OPTION A

BRIGHTON TRAINING CENTRE

OFF CHUTE

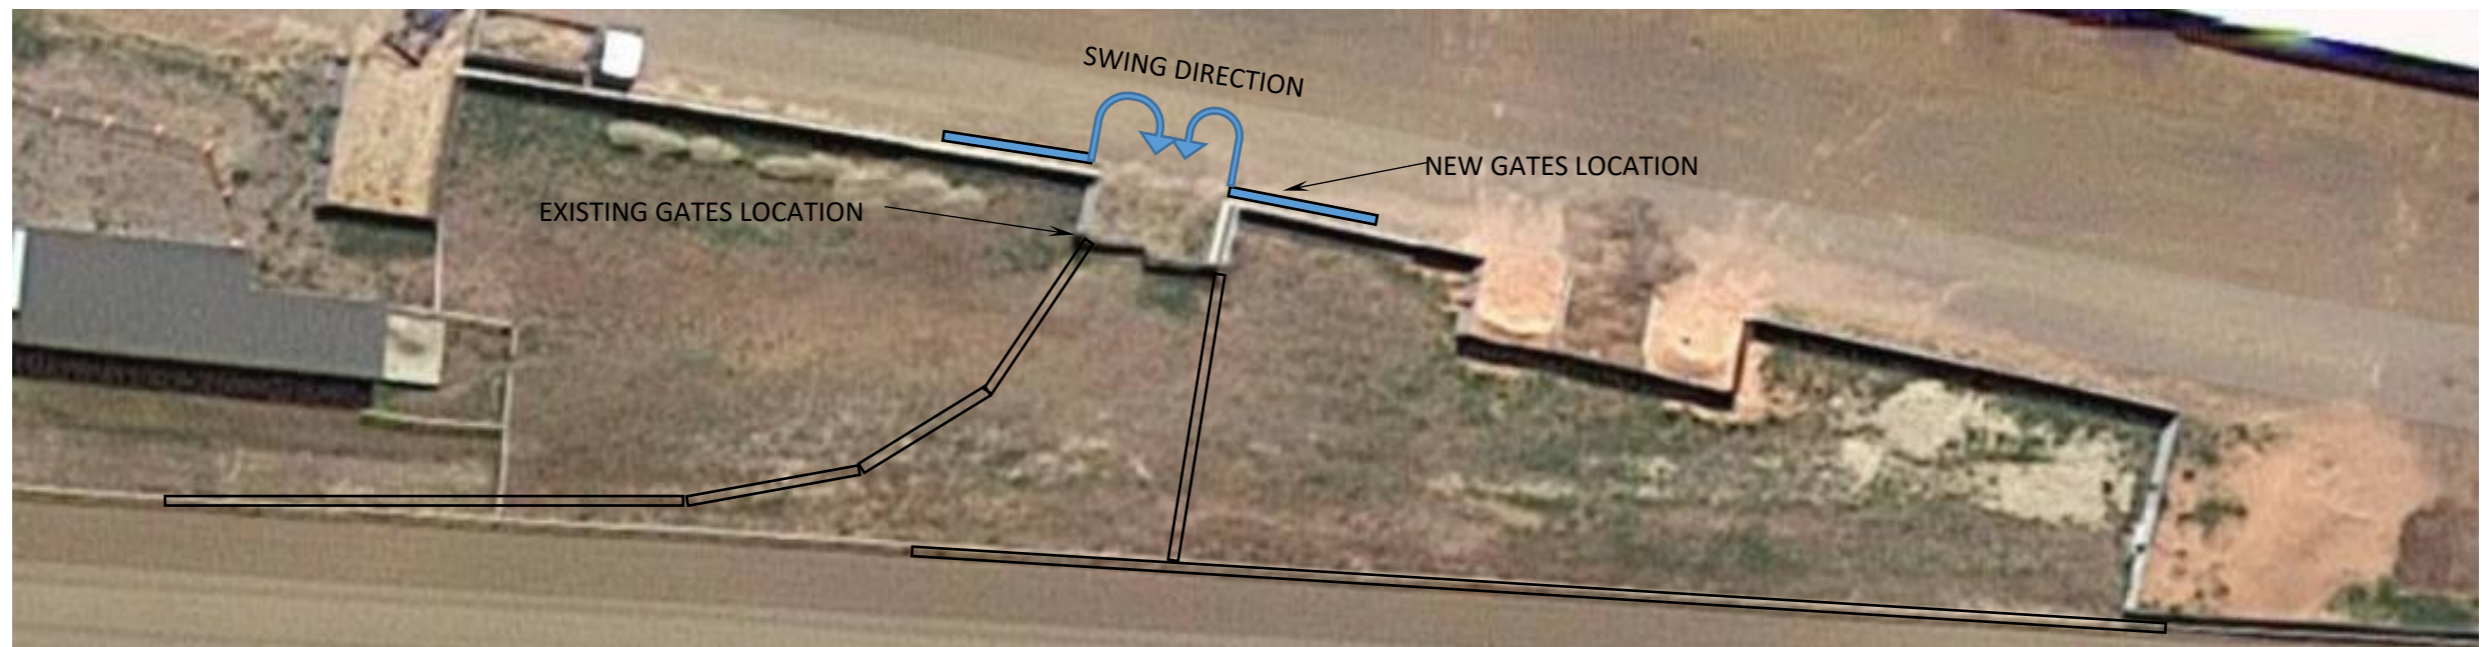
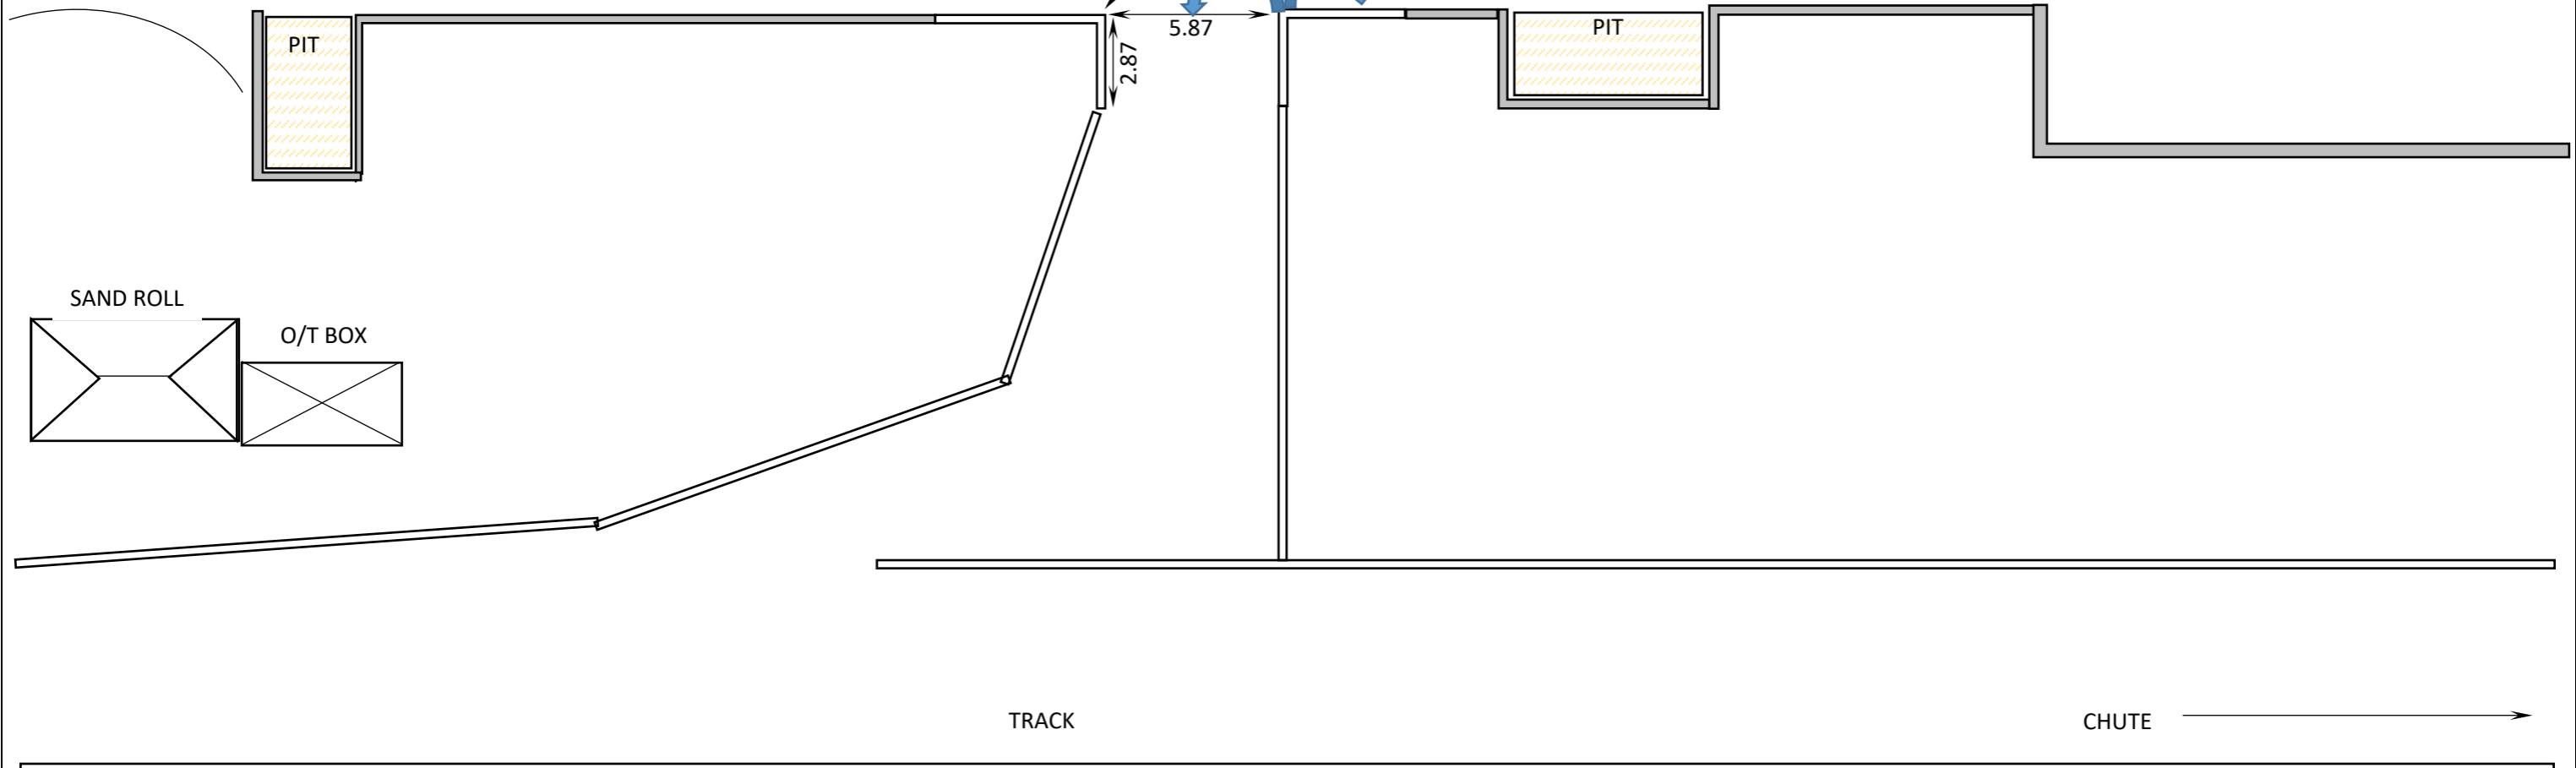
REMOVE INTERNAL SWING GATES
TO EXTERNAL SWING GATES.
ALLOWS EASIER ACCESS TO CLOSE
HORSE IN

- ALL DIMENSIONS ARE IN METERS UNLESS NOTED OTHERWISE
850mm OF COLOURBOND FENCING TO BE REMOVED FROM TOP OF FENCE LINE AND REPLACED WITH 50 x 50 4 GAUGE HOT DIPPED GALV MESH. TOTAL OF 96M. AREA ON TOP DWG IN GREY INCLUDED IN CALCULATION. COLOURBOND ALONG TRACK TO REMAIN INTACT.
